Comprehensive Development Plan Fitchburg Minerals Property

South of Lacy Road & East of Fitchrona Road
City of Fitchburg
Dane County, Wisconsin

RE:
Fitchburg Minerals
Comprehensive Development Plan
Response to Evaluation Comments
Received July 2021

PLAN COMMISSION MEMO 06/29/2021

LAND USE PLAN

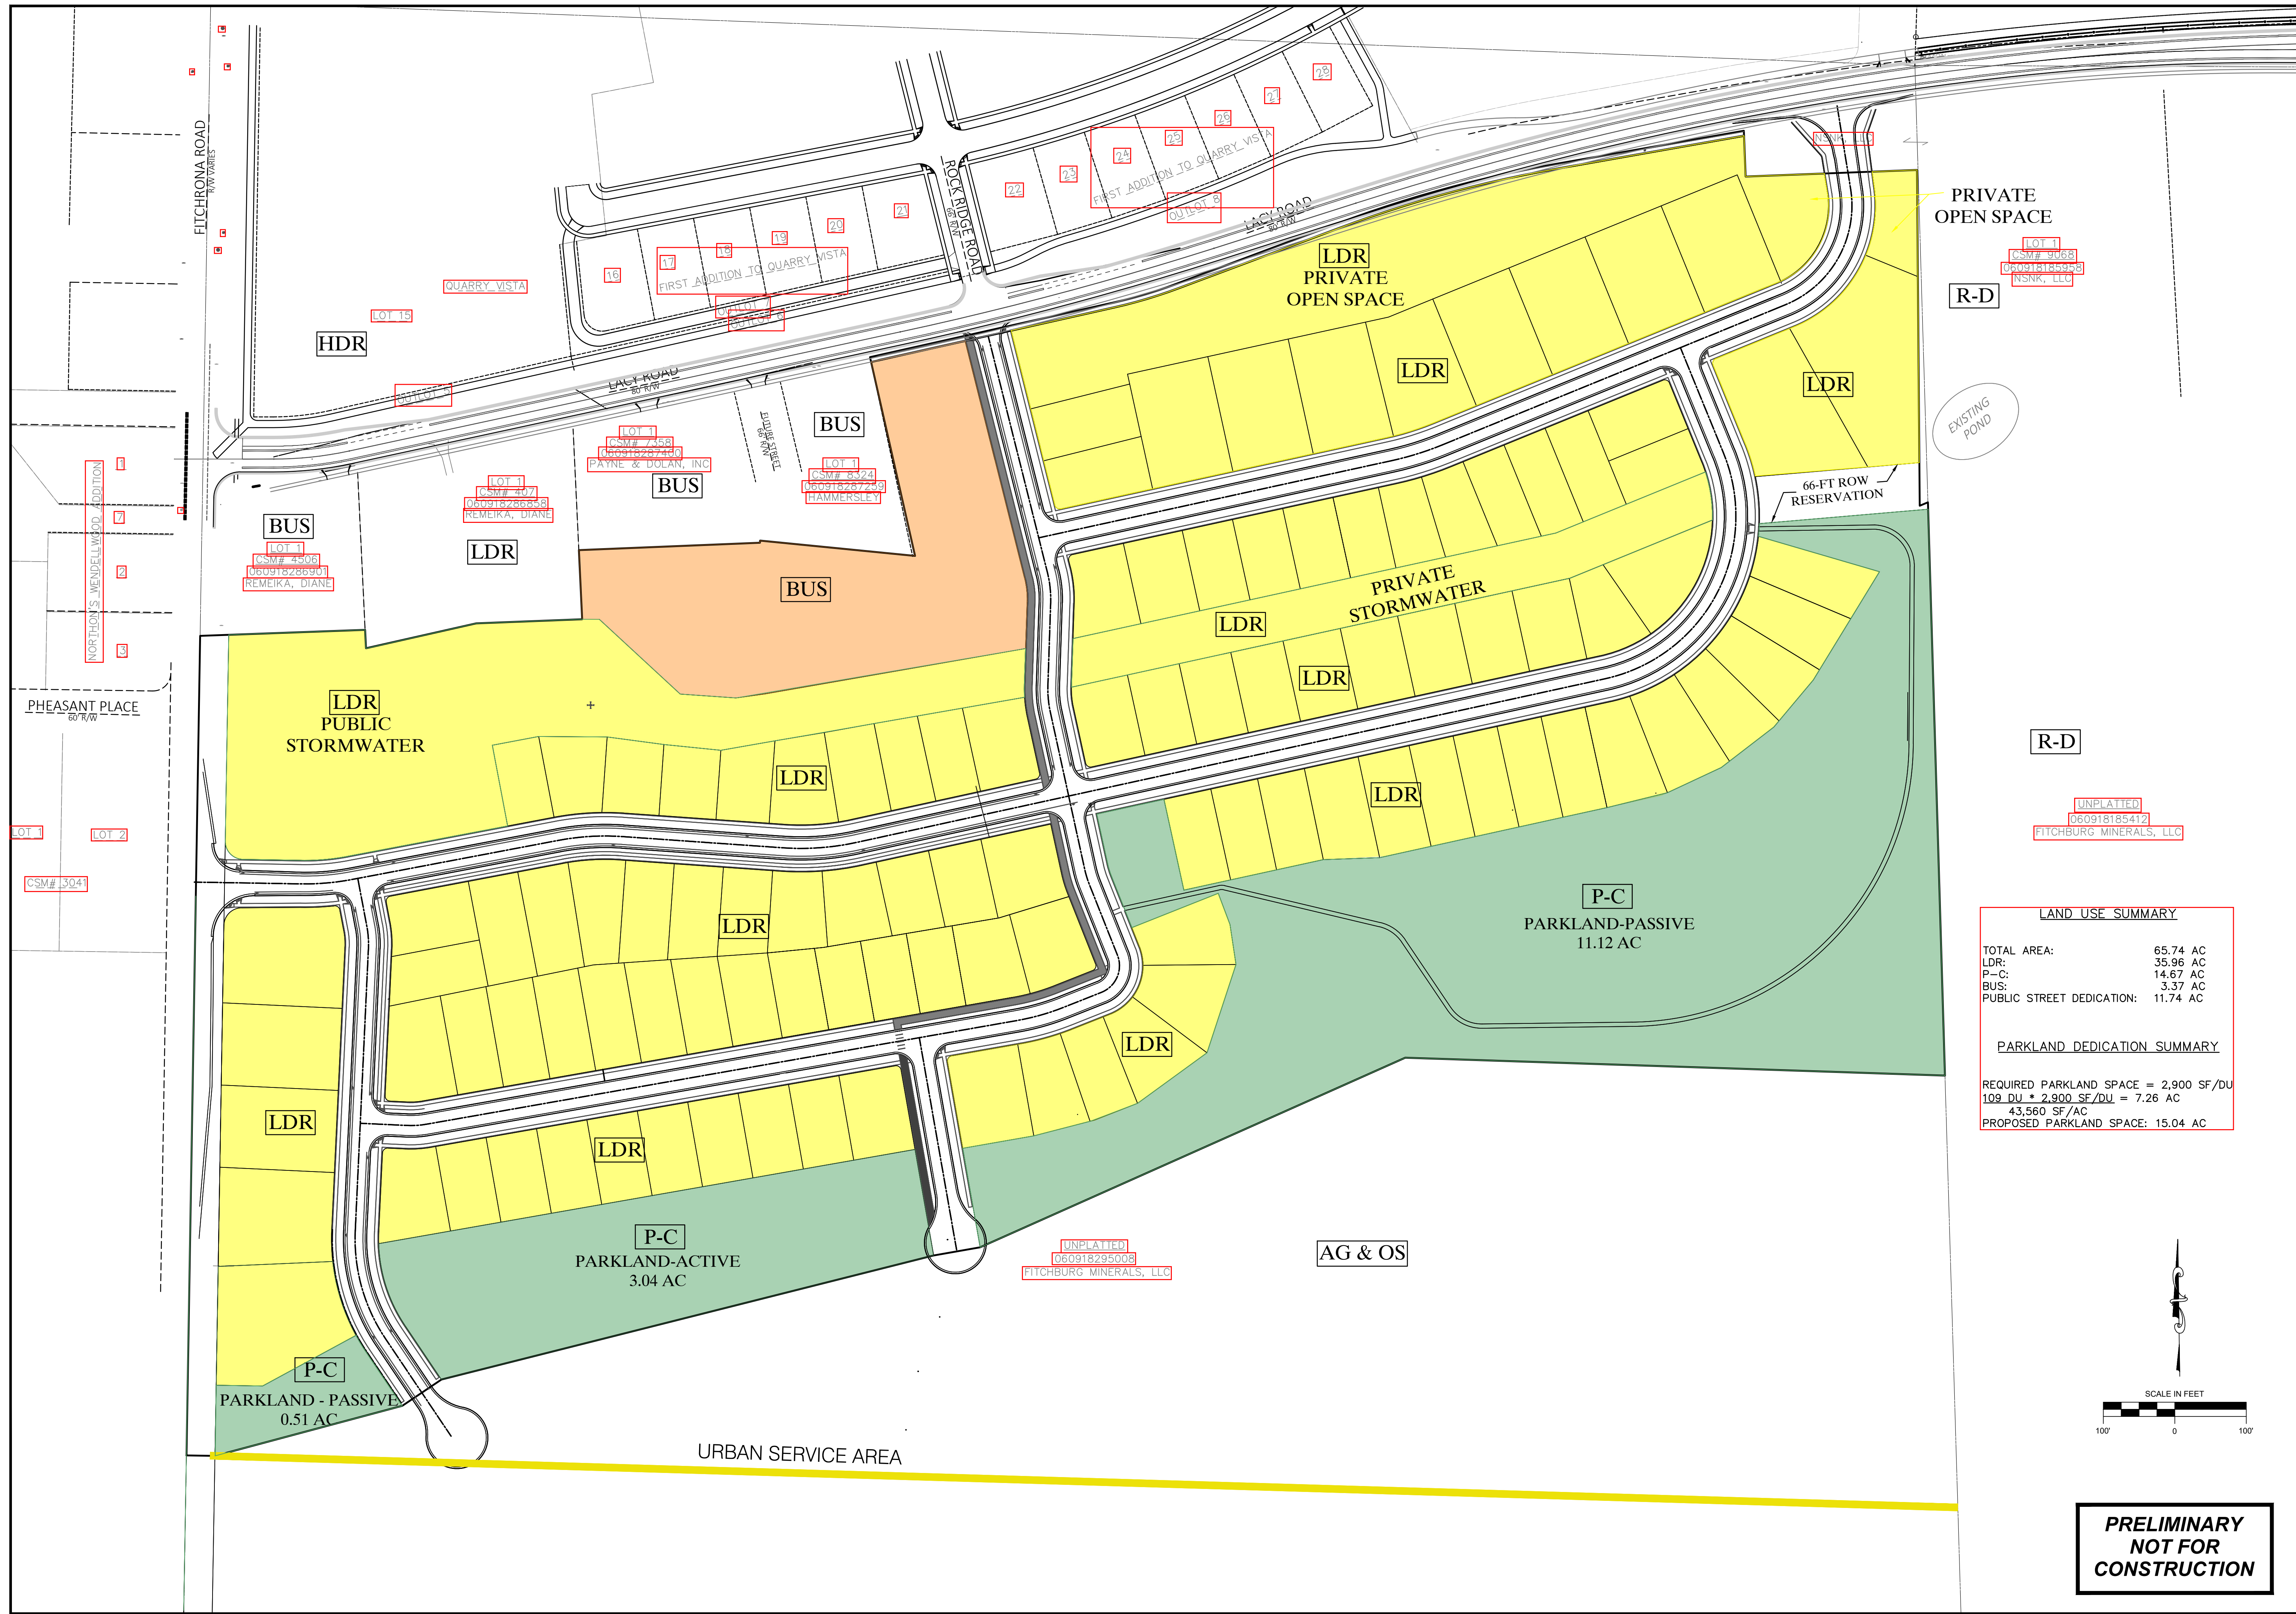
- a. No response warranted.
2. All lands within the CDP boundaries have a future land use designation as LDR (Low Density Residential). The revised CDP shows a business land use on approximately 3 acres on a proposed outlot. This is not consistent with the Comp Plan and should be removed. Business reference in the narrative of the document should also be removed. The preliminary plat proposed zoning of B-P should also be removed.

- a. The reference has been removed.
8. Will the development meet the required land dedication for parks? 2,900 sf required per unit in dedication, or pay a fee in-lieu of dedication. Please provide the calculation within the narrative. Park improvement fees will be due for each unit.

- a. Comments were received previously from the plan commission and elected officials that medium and high density residential was not desired at this location previously. Given the immediate proximity to the existing business uses at this location and Payne & Dolan's need for additional office space in Fitchburg, the land use of Business was left in the CDP for further discussion with the Plan Commission, Elected Officials and staff.

- a. Sufficient parklands will be dedicated with the development to satisfy the requirements. The computation has been added to the zoning exhibit.
9. The Lacy Road and Fitchrona Road street connections may be required at an earlier time than shown in the phasing plan. Review and discuss with Public Works.

CONCEPTUAL MASTER GRADING PLAN

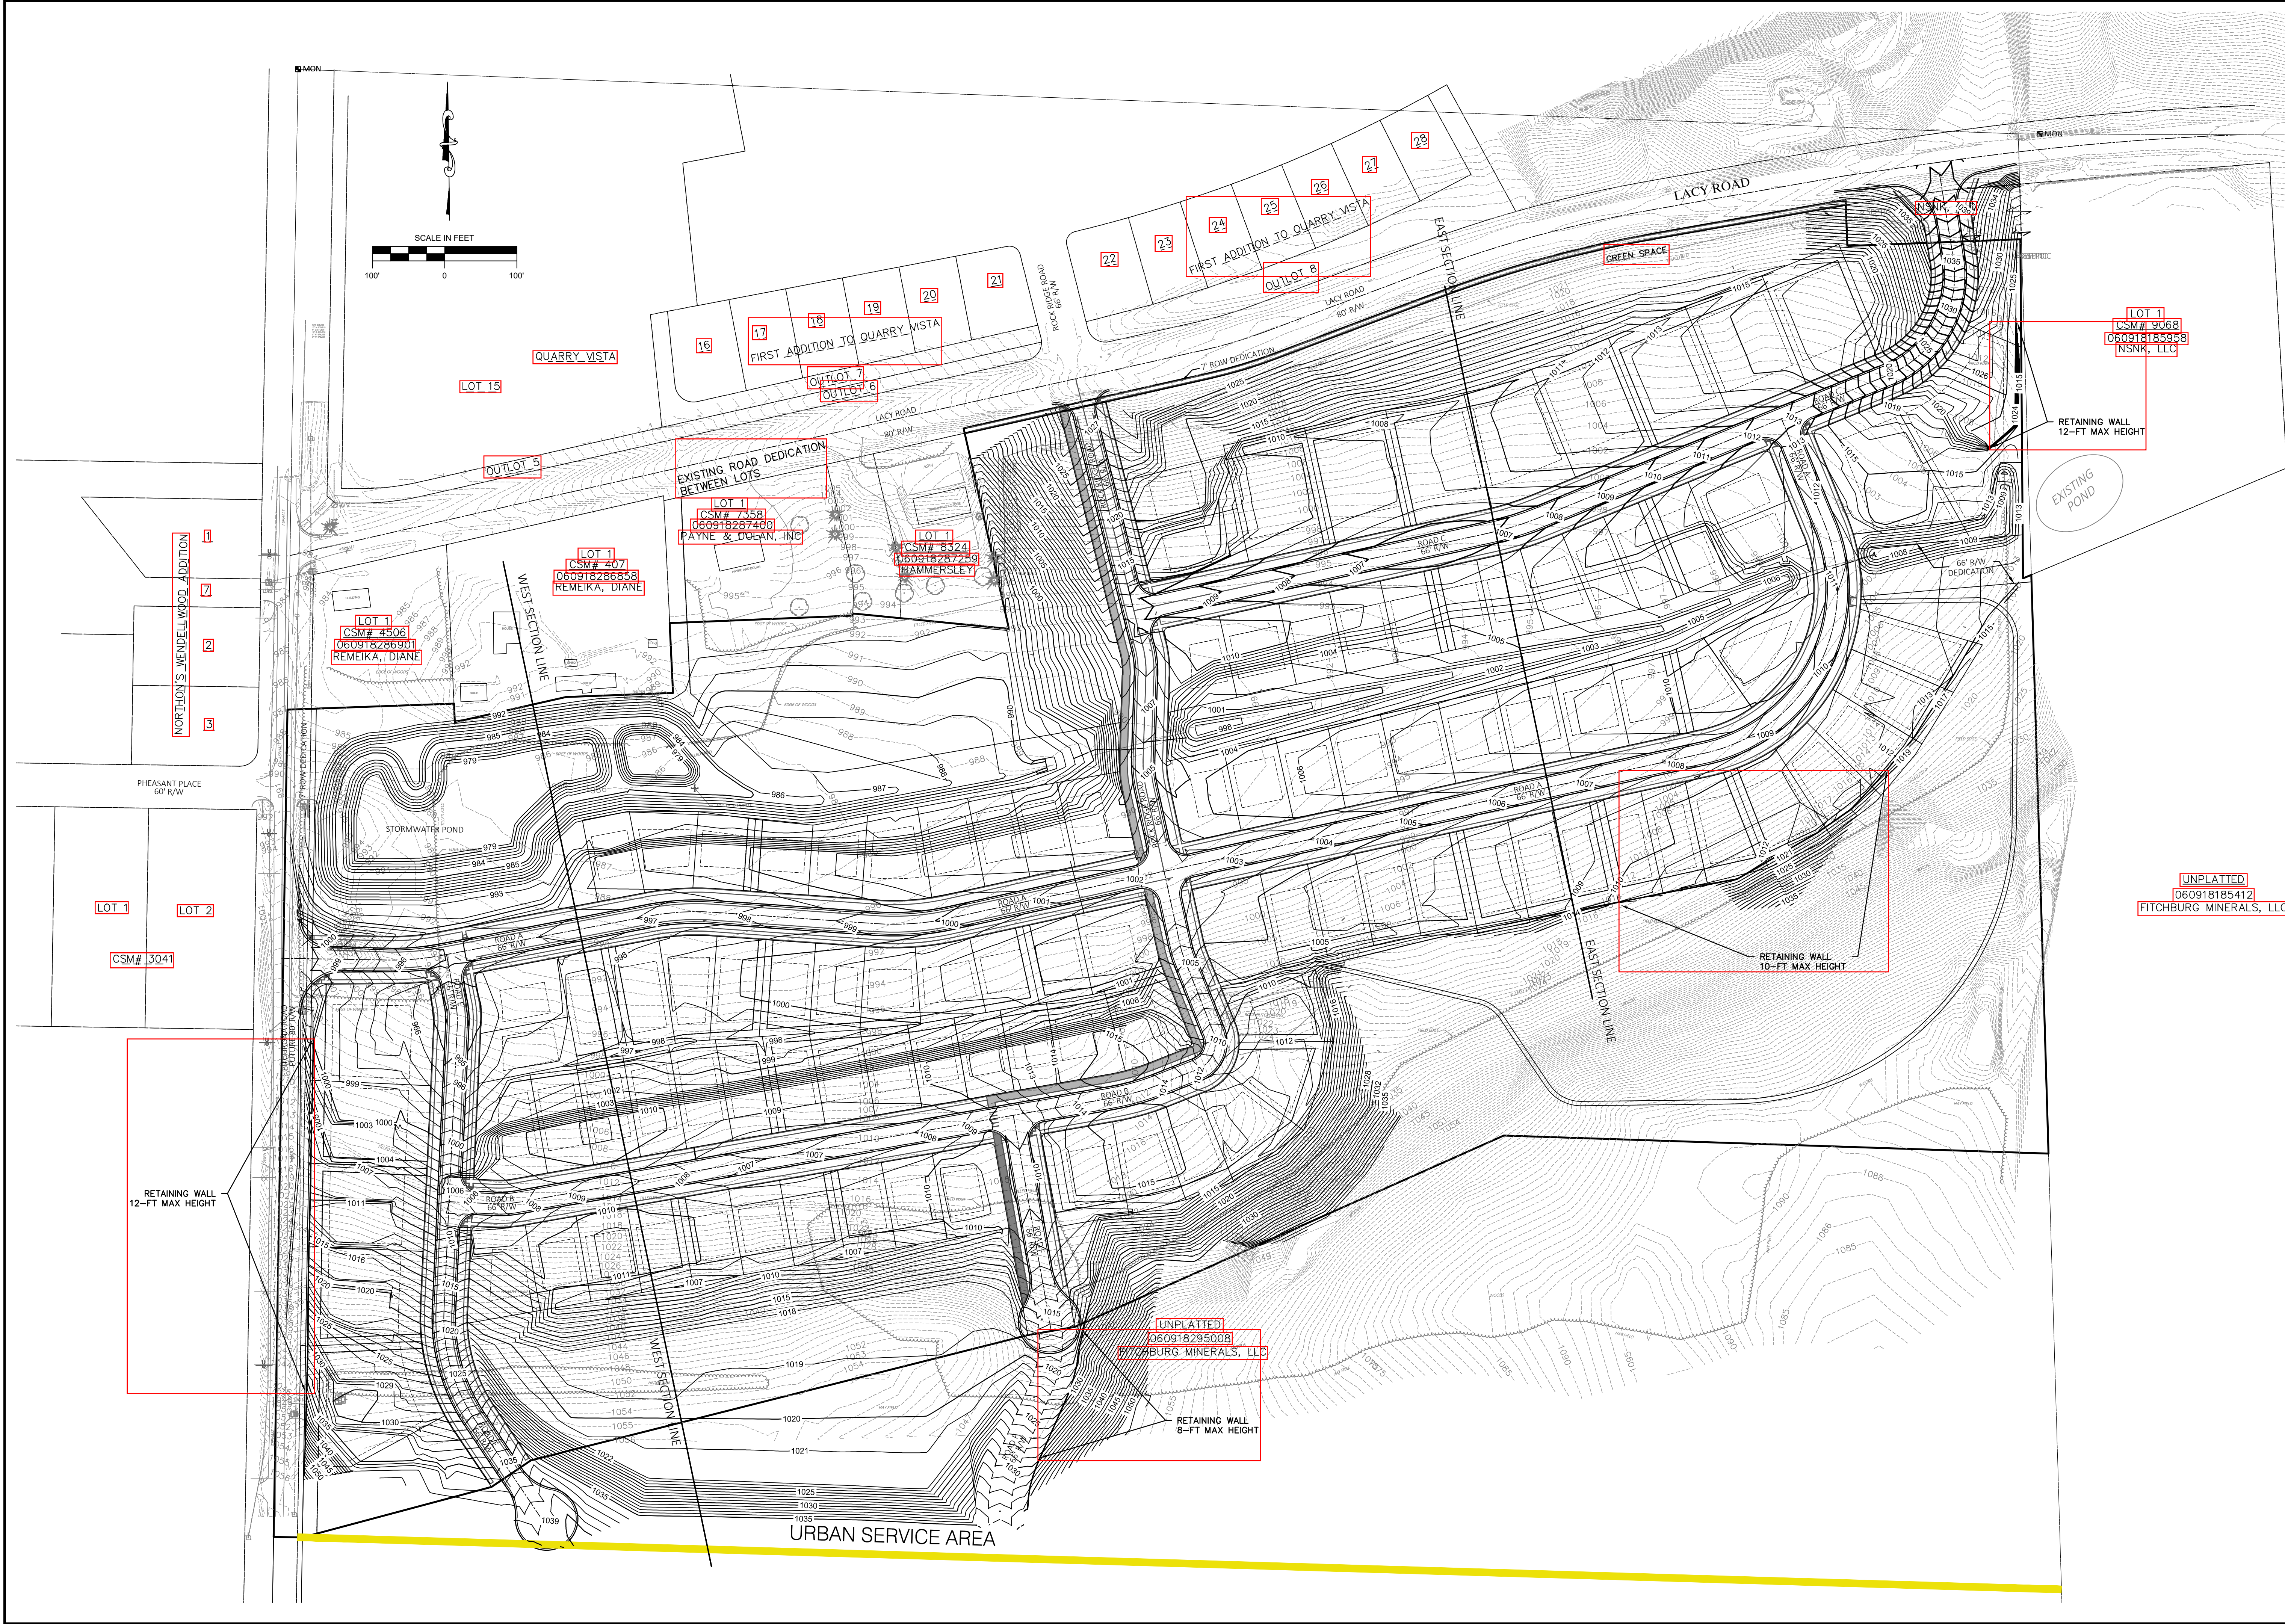
- a. A tree survey has not been completed.
13. What will the grading of rear yards (backing up to Lacy Road) look like? Some areas exceed 12% slopes.
 - a. A detailed grading plan has been provided as well as two sections developed thru the development.

5. Will the existing steep topography be an issue, or will they be excavating the site (TB)?
 - a. A significant amount of earthwork is anticipated for this development. A detailed preliminary grading plan has been developed and will be further refined as the approval process advances.
